**SUBJECT: EDWIN I. HATCH NUCLEAR PLANT, UNIT NOS. 1 AND 2 – ISSUANCE OF AMENDMENTS TO REVISE TECHNICAL SPECIFICATION 3.3.8.1, “LOSS OF POWER (LOP) INSTRUMENTATION” (EPID L-2018-LLA-0069)**

SAFETY EVALUATION BY THE OFFICE OF NUCLEAR REACTOR REGULATION

EDWIN I. HATCH NUCLEAR PLANT, UNIT NOS. 1 AND 2

**Figure 2:** NRC Staff's Independent Calculation of AV Margin and NTSP Degraded Voltage Margin for Proposed DVR Buses (Note: LAT = Leave Alone Tolerance)

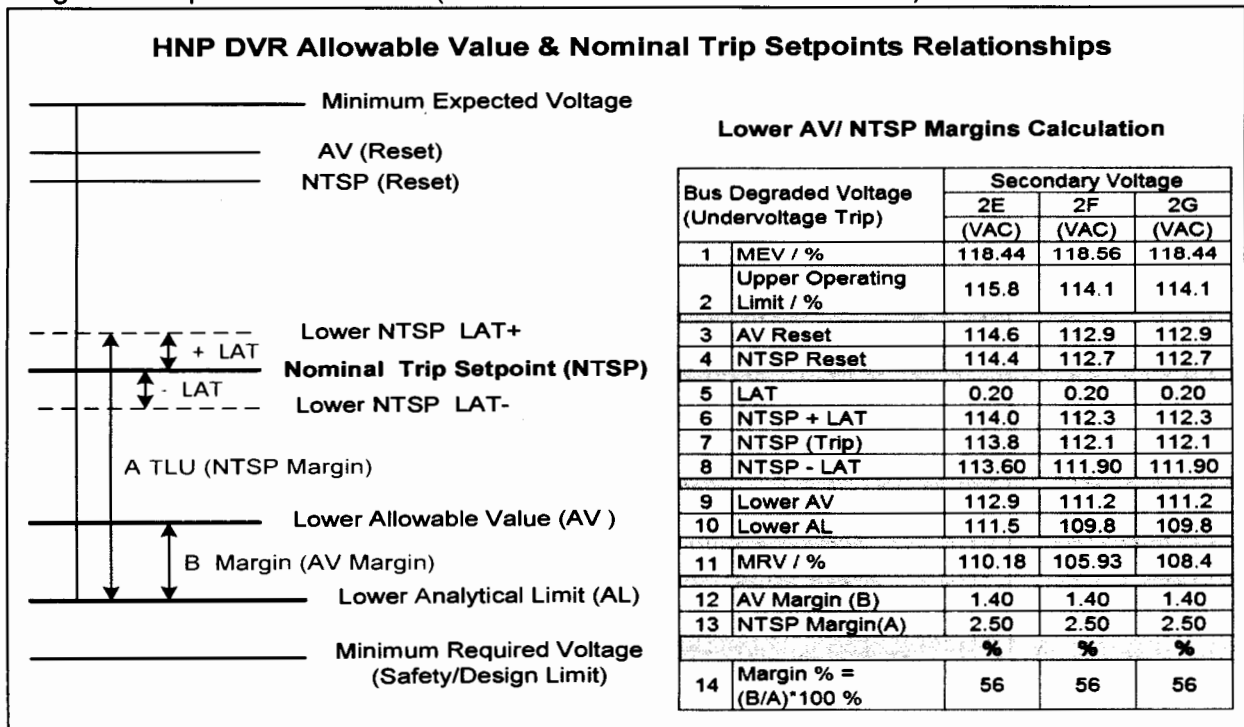
The NRC staff applied the guidance in RG 1.105, Revision 3, to confirm independently whether adequate margins are provided for instrument channel performance uncertainty between the ALs and the NTSPs and associated AVs. The NRC staff independently calculated the margin percent (%) as the ratio of AV margin to NTSP margin (for the Unit No. 2 4.16 kV Emergency Bus Undervoltage function), and the calculation results are shown in Figure 2 below.

Based on its review of the information in Attachment 4 of the LAR, as summarized, in part, in Figure 2 above, the NRC staff has determined the following with respect to the proposed AVs for Function 2.a in TS Table 3.3.8.1-1:

- (2) The MRV values were calculated based on a "bottom up" approach, as discussed in NRC RIS 2011-12. All voltage requirements for the safety-related equipment are preserved by the proposed DVR settings. The licensee's evaluation includes the minimum voltage required during steady-state or pre-start individual or group motor starting at the safety-related 4160 V buses. The DVR setpoints provide reasonable assurance that adequate voltage is available for operation (starting and running) of all safety-related loads.

- (7) The resulting Lower ALs are higher than the MRV values (as indicated in Rows 10 and 11 of Figure 2) and are reasonable. The MRVs are calculated from the ETAP simulation for each Unit No. 2 4160 V emergency bus and assumed the worst case loading conditions, which ensures the ALs are not exceeded, consistent with the HNP safety analysis.

Based on its review and the above evaluation, the NRC staff finds that the proposed degraded voltage settings (ALs, AVs and NTSPs) for the Unit No. 2 4160 V emergency buses are reasonable and provide a high confidence level that safety-related equipment will be adequately protected against a degraded voltage condition. These changes further satisfy the requirements of GDCs 13 and 17. Therefore, these proposed changes are acceptable.

**Figure 3: NRC Staff's Independent Calculation of AV and NTSP Time Delay Margins for HNP Unit No. 2 Emergency Buses with New DVRs**

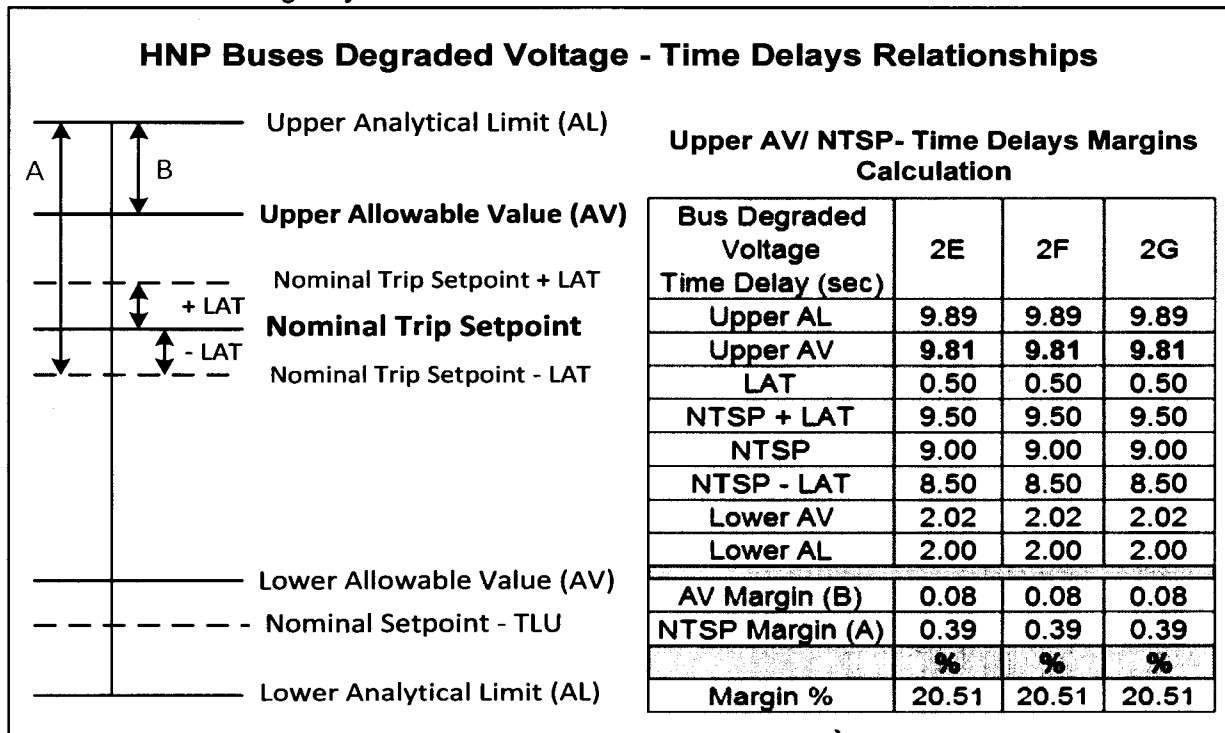
The NRC staff calculated the margin percent (%) between AV margins and NTSP margins applicable to the Unit No. 2 4.16 kV Emergency Buses – Time Delay function. The calculation results and the proposed 4.16 kV Emergency Buses Degraded Voltage Time Delays are illustrated in Figure 3 below.

The proposed time delay settings for the new DVRs are  $\leq 9.8$  sec.

As summarized in Figure 3 above, the NRC staff verified that:

- (1) For a pre-start voltage at or below the MRV, the LOCA motor starting transient time was less than the DVR time delay setting of  $\leq 9.8$  seconds, including tolerances, which will preclude spurious trips for the Unit No. 2 safety-related buses.
- (2) The DVR time delay setting ( $\leq 9.8$  seconds), including tolerances, was less than the DG start time of 12 seconds assumed in accident analyses. This setpoint provides reasonable assurance that the response times for emergency core cooling systems assumed in the accident analyses are not exceeded during extended degraded grid conditions.
- (3) The DVR time delay setting, including tolerances, was less than the minimum overcurrent relay trip time. This prevents inadvertent tripping of safety-related equipment during allowable degraded voltage conditions

The NRC staff has reviewed the licensee's proposed changes to the Unit No. 2 Renewed Operating License and to the HNP TS for both units, and the supporting documentation related to the electrical power system modifications affecting the LOP instrumentation for HNP Unit No. 2. The current TS allowable values associated with the Unit No. 1 4160 V emergency bus LOP instrumentation are not modified, and the current Unit No. 1 annunciator requirements are retained, as discussed in the LAR. The proposed license amendment is an interim license change to support implementation of the Unit No. 2 portion of the electrical power system modification at the Hatch Nuclear Plant. Based on the above, the NRC staff has determined that the proposed changes to the HNP TS will provide reasonable assurance that automatic actuation of the degraded voltage relays will ensure proper equipment performance during postulated design basis events. The NRC staff has concluded that the proposed changes meet the requirements of GDC 13 and 17, 10 CFR 50.55(h)(2), and 10 CFR 50.36. Therefore, the staff finds the proposed changes acceptable.
